**SHARON DEPARTMENT OF PUBLIC WORKS
TOWN OF SHARON, MASSACHUSETTS**

**WELLS 2, 3, AND 4 WATER TREATMENT PLANT
CONTRACT NO. 2025-101 (DWSRF #12443)**

ADDENDUM NO. 1

May 2, 2024

E-3

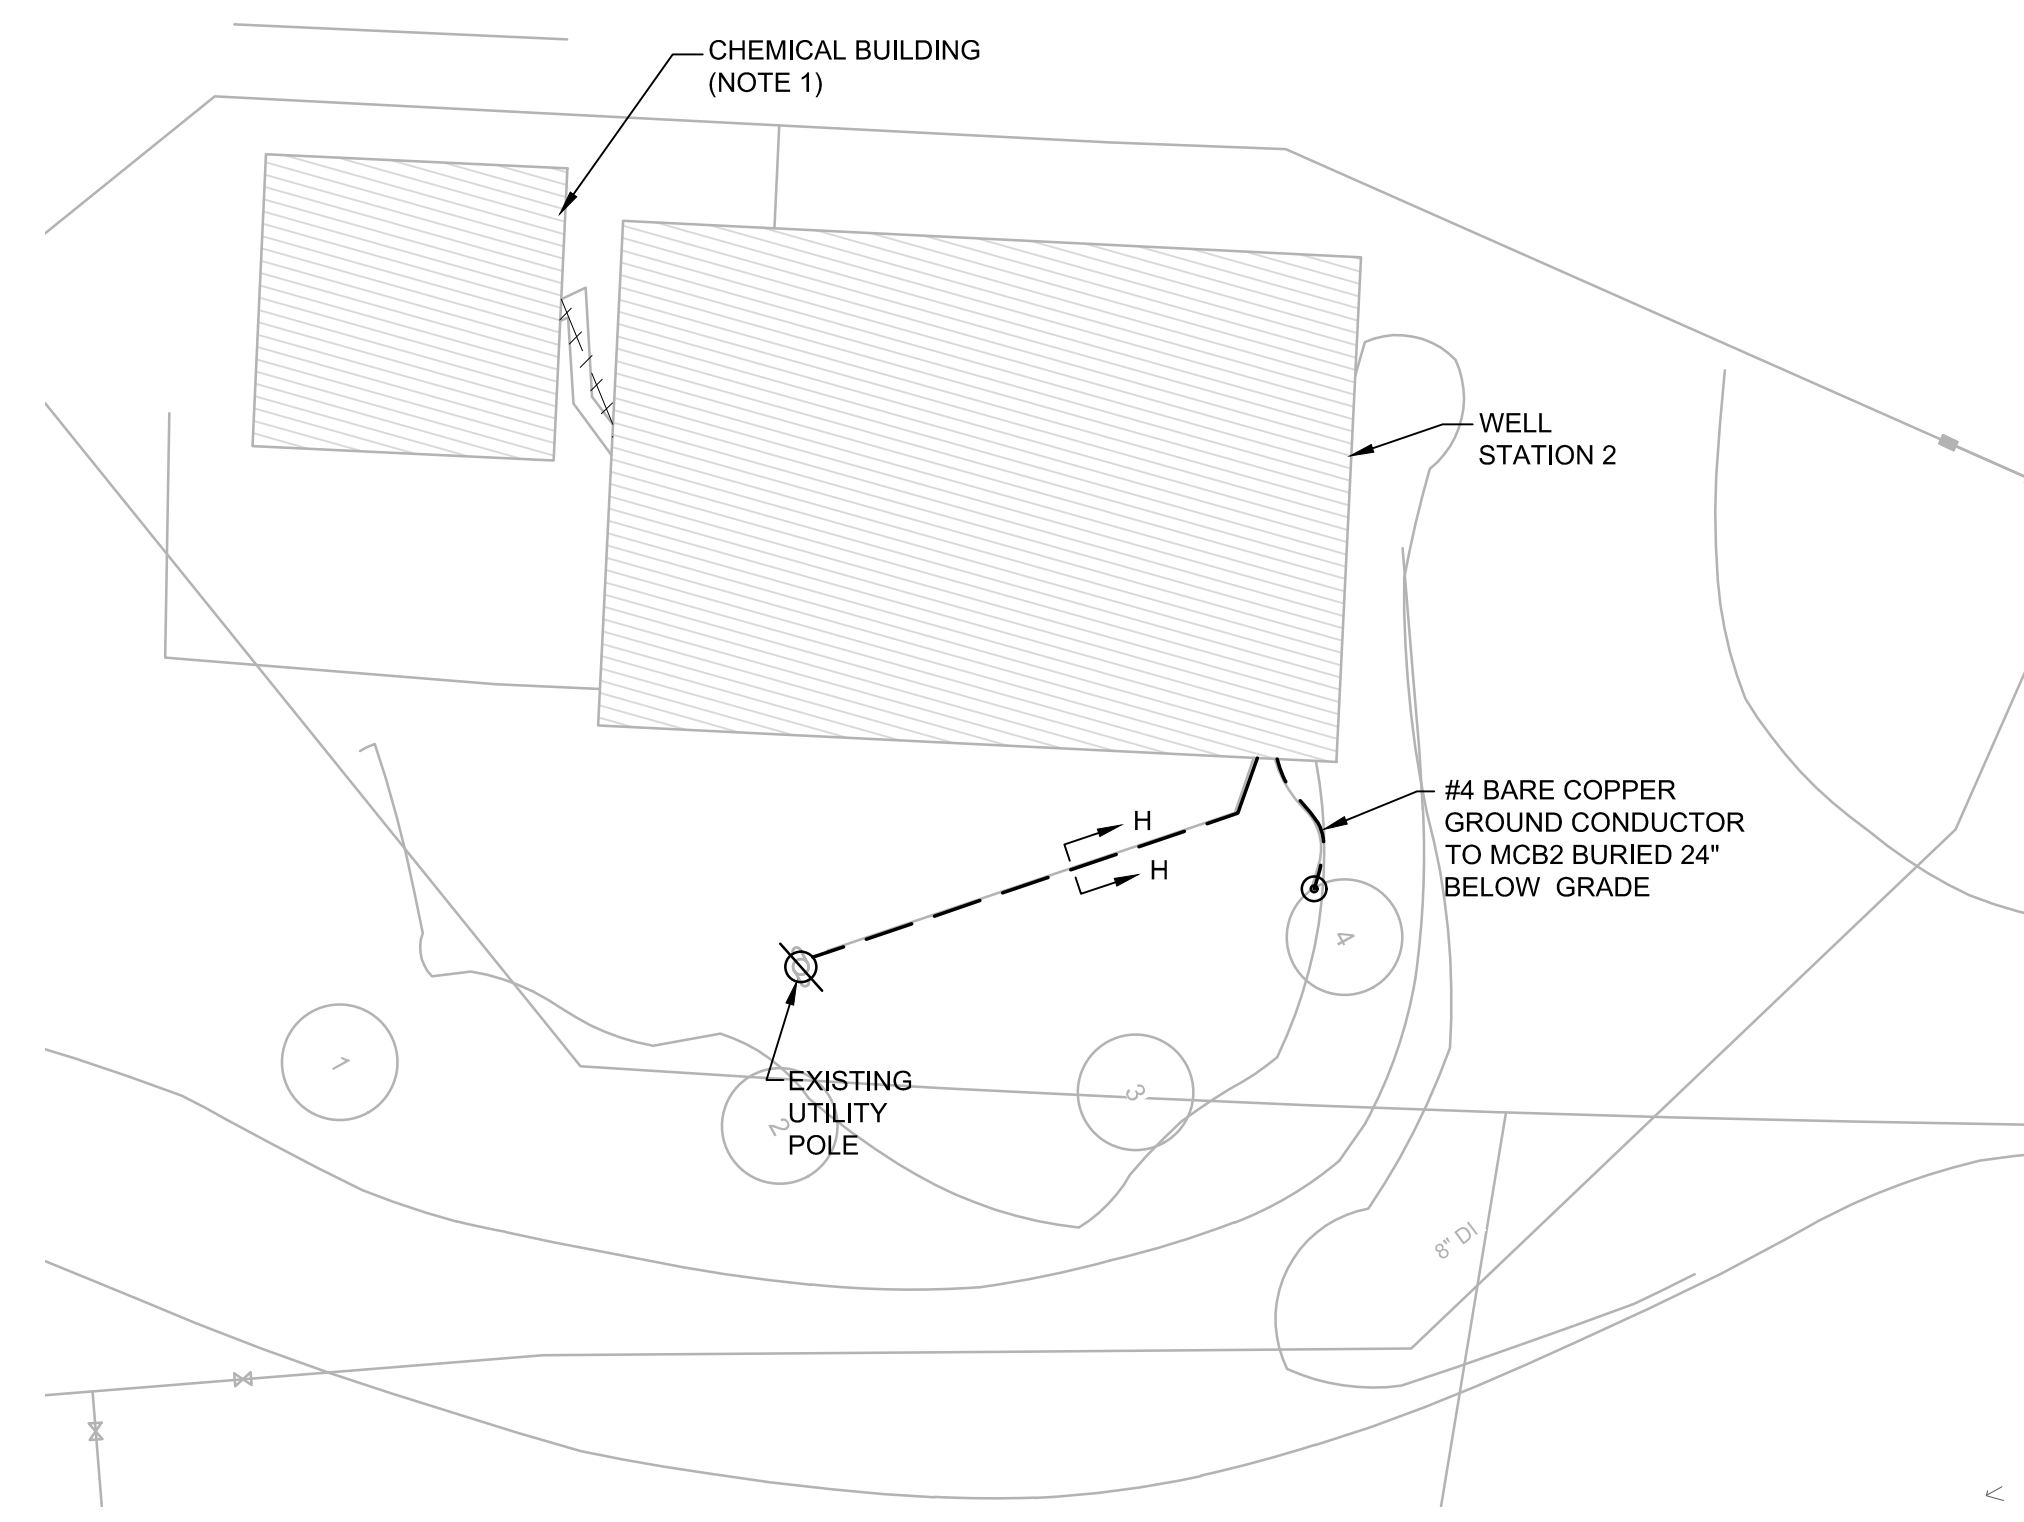
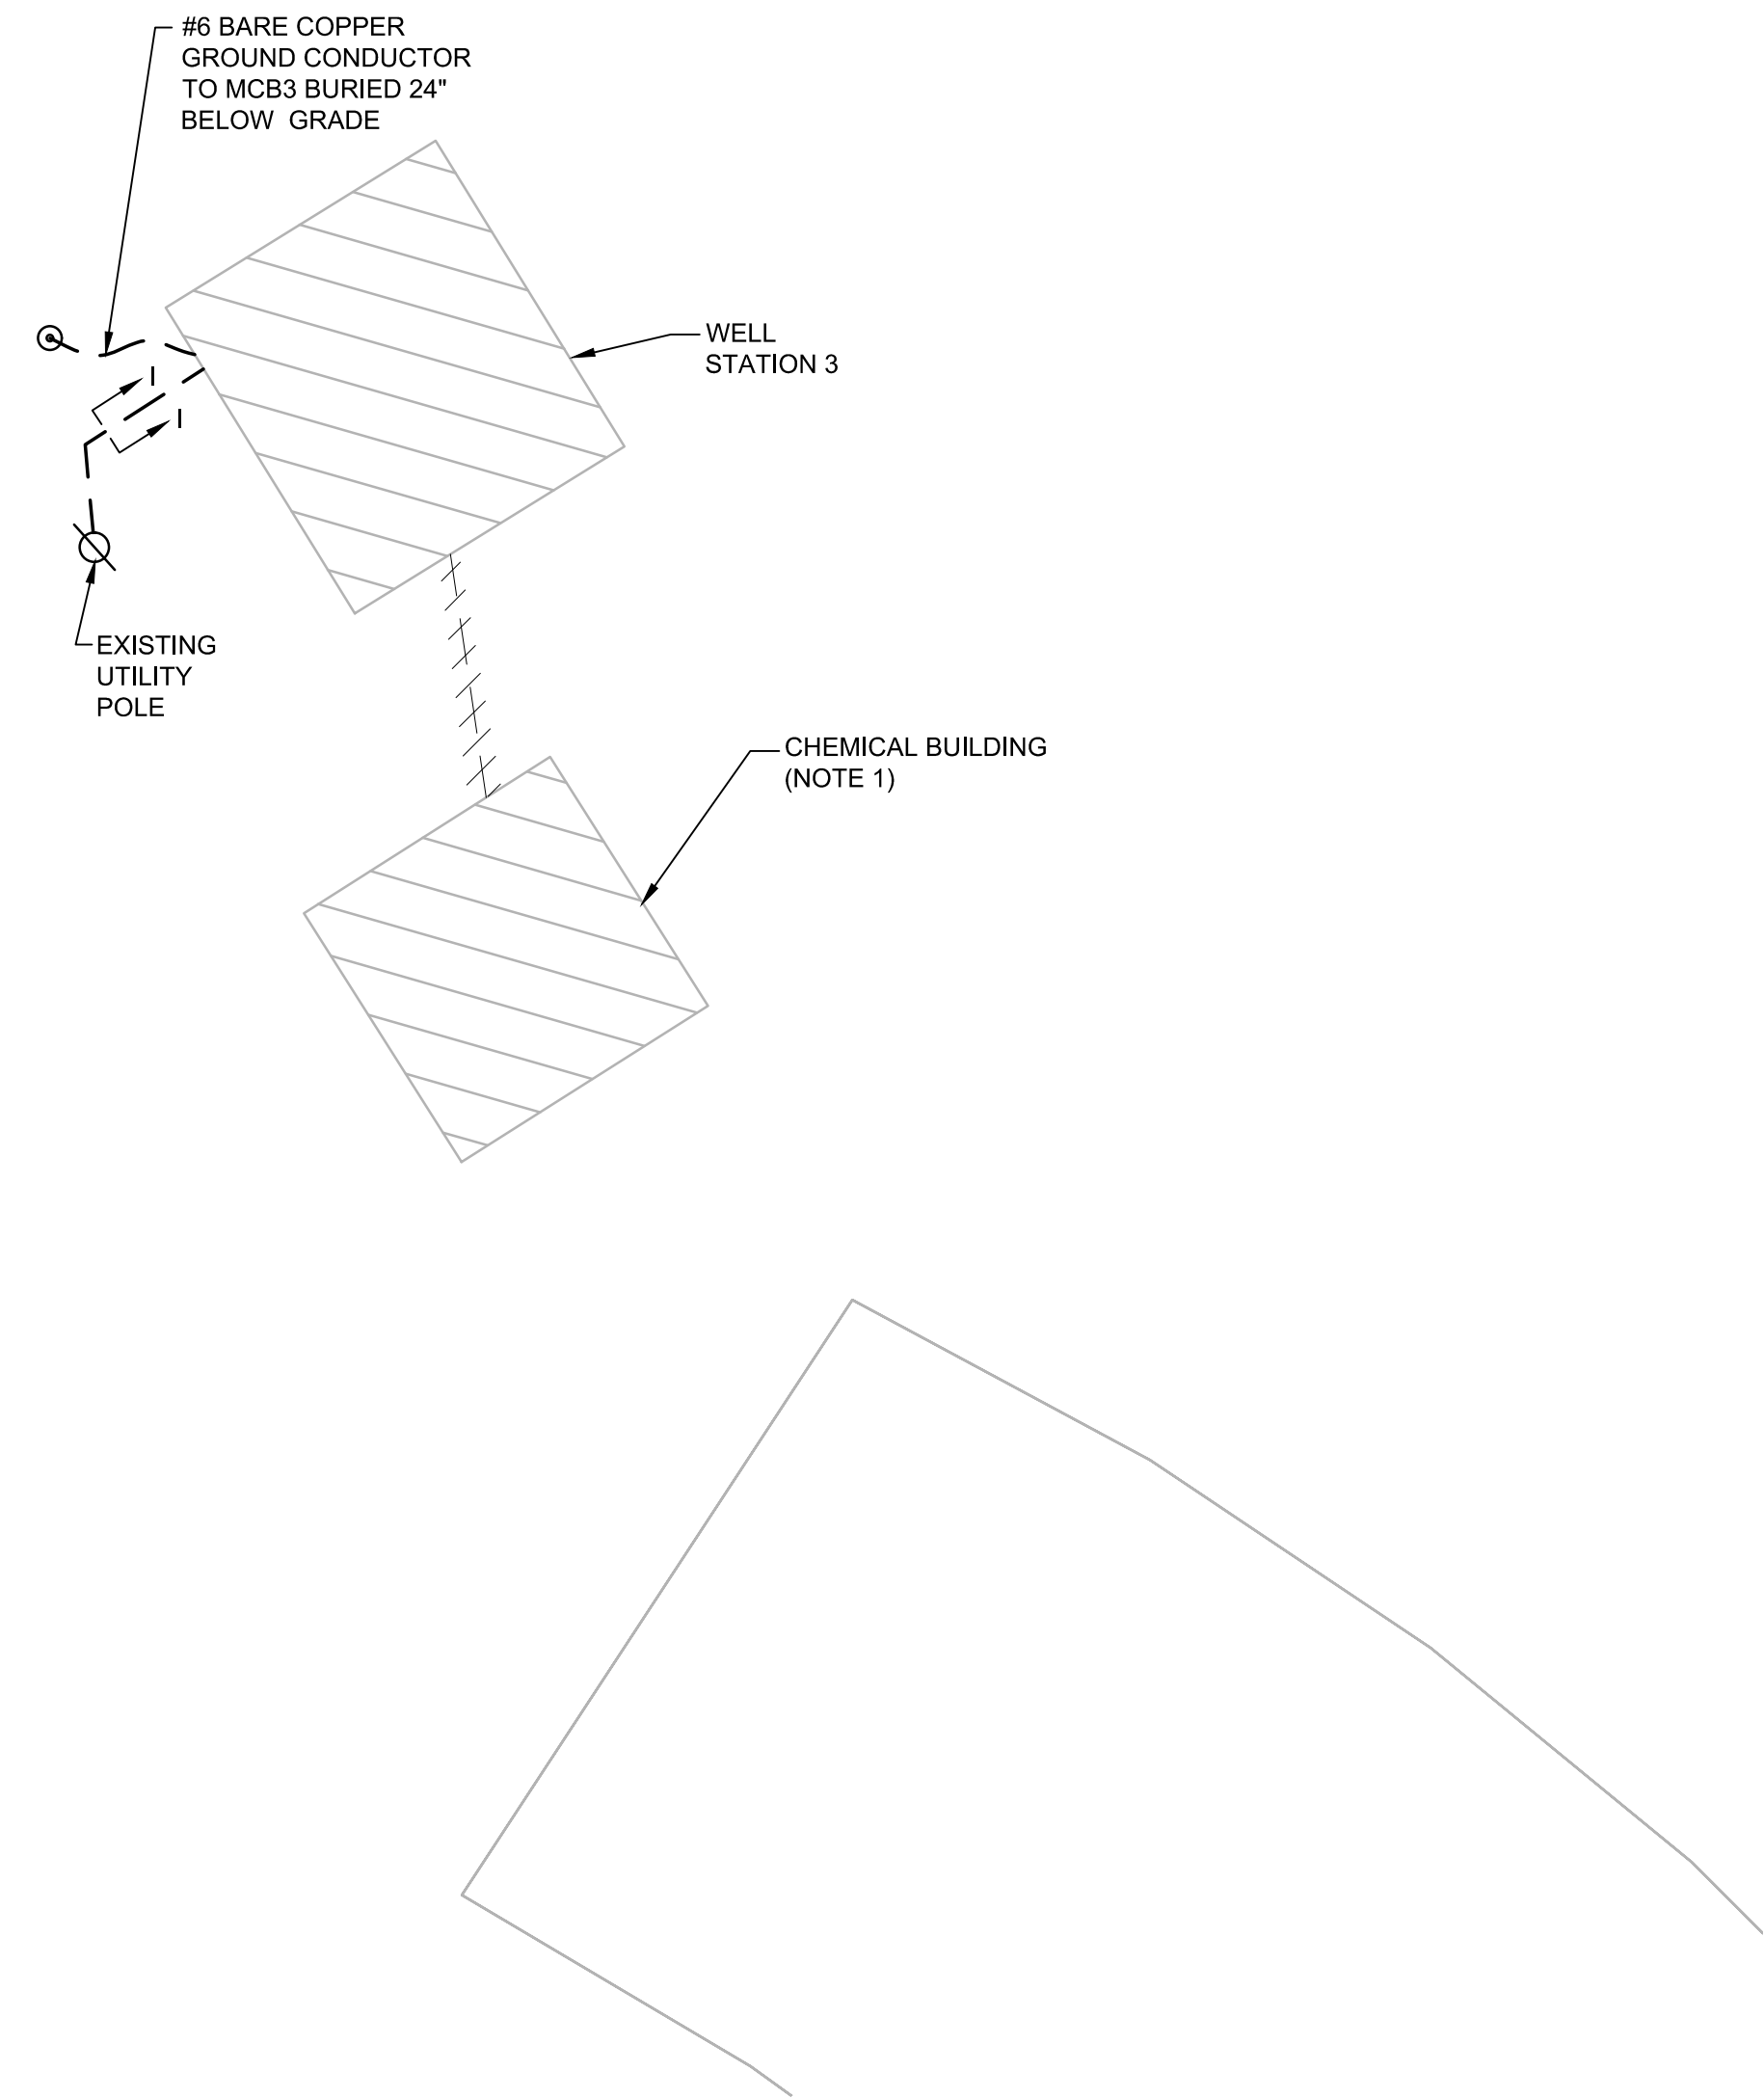
Question 20: Who is responsible for draining the fluids from the existing generator and relocating it to the owner's site?

Answer 20: Refer to Addendum No. 1, Attachment 5, Sheet E-3.

WALL TRANSITION DETAIL

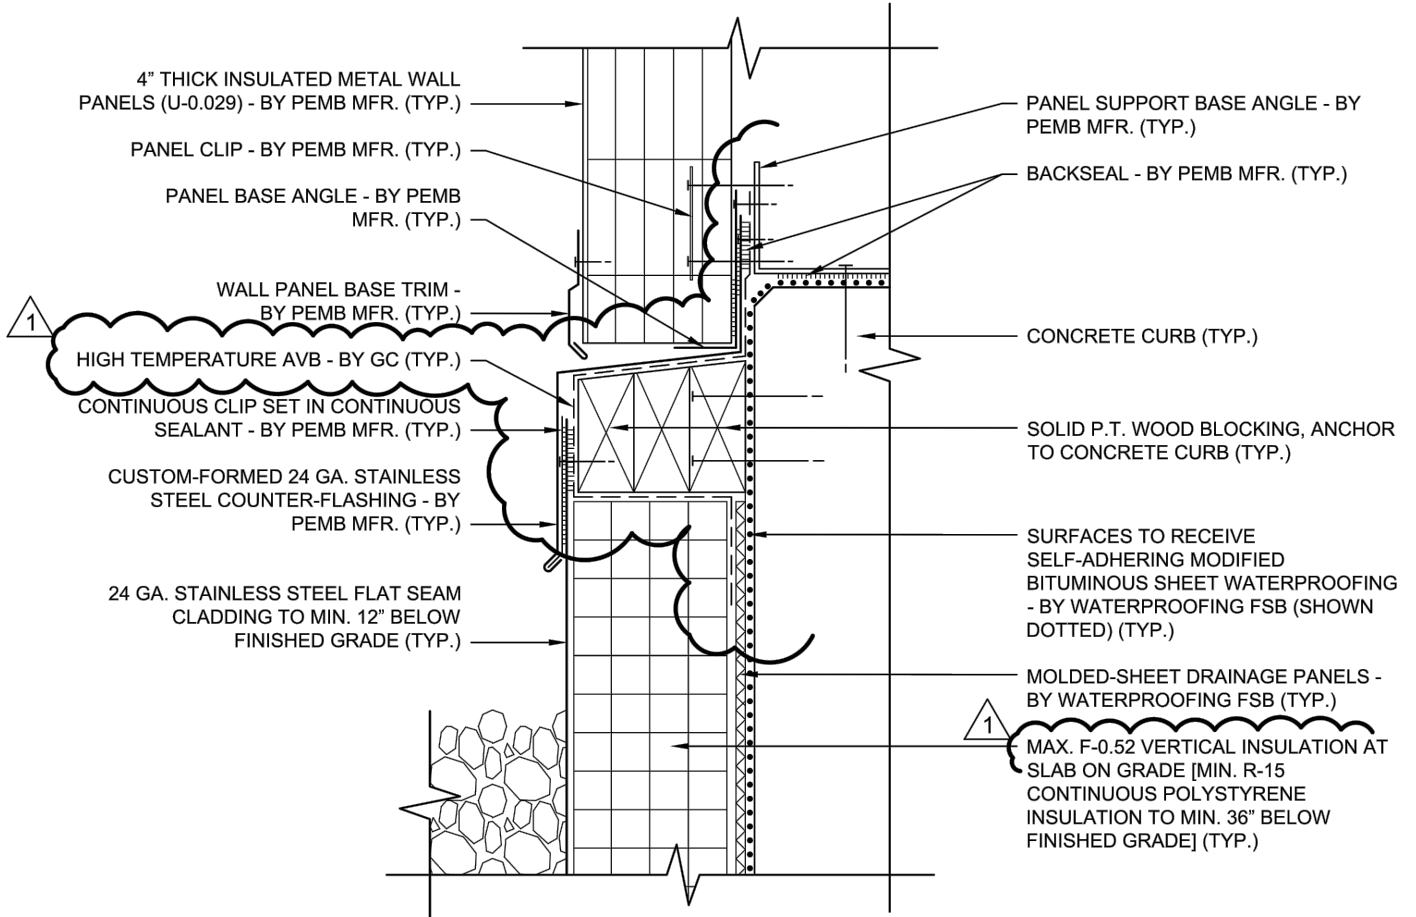
- At Detail 2, Exterior Wall Section, revise detail call-out from “MIN. F-0.52 VERTICAL INSULATION...” to “MAX. F-0.52 VERTICAL INSULATION....”
- At Detail 3, Exterior Wall Section, revise detail call-out from “MIN. F-0.52 VERTICAL INSULATION...” to “MAX. F-0.52 VERTICAL INSULATION....”
- At Detail 4, Exterior Wall Section, revise detail call-out from “MIN. F-0.52 VERTICAL INSULATION...” to “MAX. F-0.52 VERTICAL INSULATION....”
- At Detail 5, Wall Transition Detail, revise the detail per Attachment 8, Sheet SKA-1.

<p>ENVIRONMENTAL PARTNERS — An Apex Company —</p>	APRIL 2024	WELLS 2, 3, AND 4 WATER TREATMENT PLANT
	245-2103	ADDENDUM NO. 1
	SKA-1	REVISIONS TO WALL TRANSITION DETAIL 5/A-16

CONCRETE FACED INSULATION:
WALL TRANSITION DETAIL

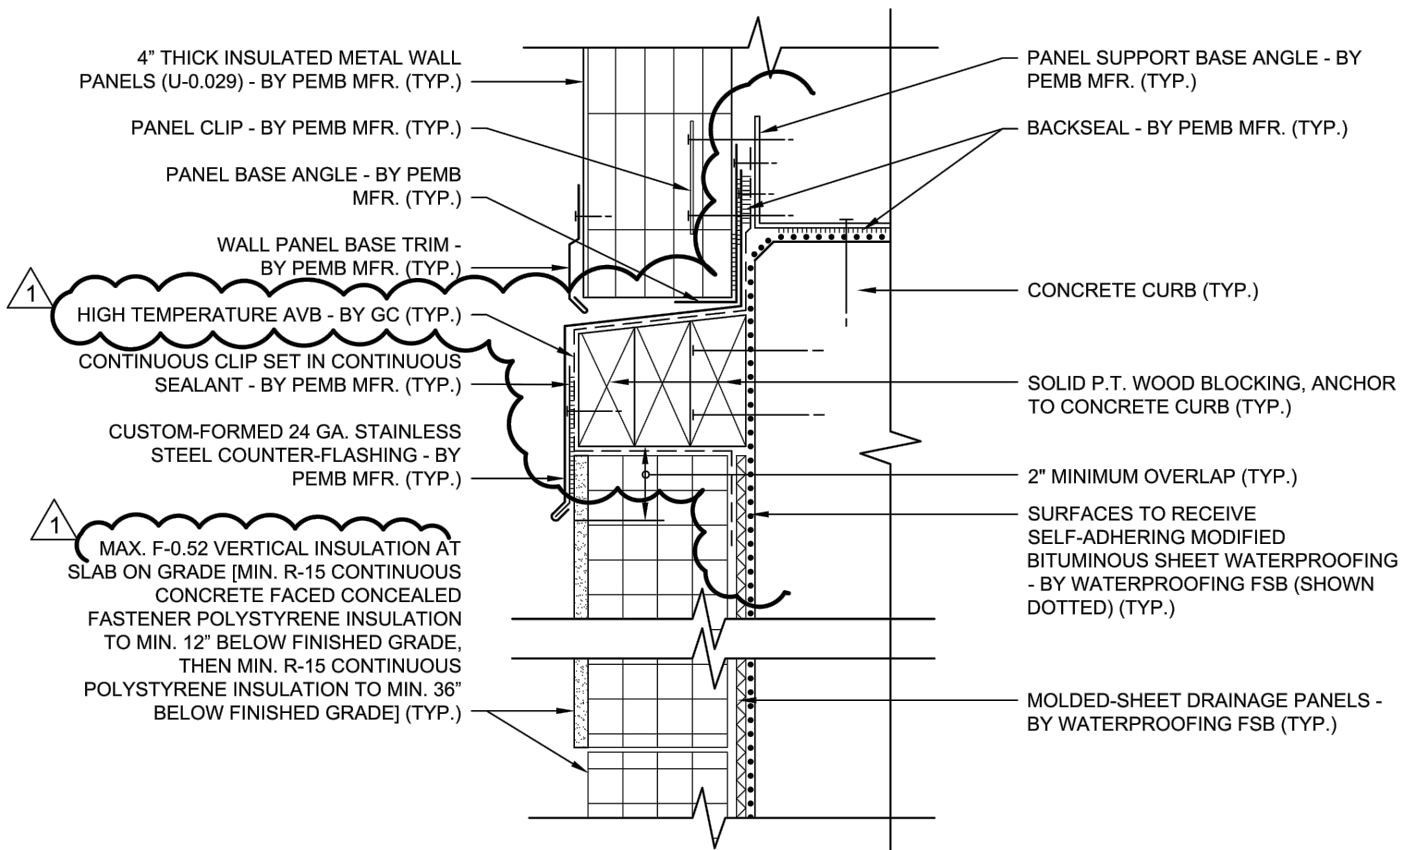
- At Detail 6, Wall Transition Detail, revise the detail per Attachment 8, Sheet SKA-2.
- At Detail 7, Wall Transition Detail, revise the detail per Attachment 8, Sheet SKA-3.
- At Detail 8, Wall Transition Detail, revise the detail per Attachment 8, Sheet SKA-4
- At Detail 9, Typical Ridge Detail, revise the detail per Attachment 8, Sheet SKA-5
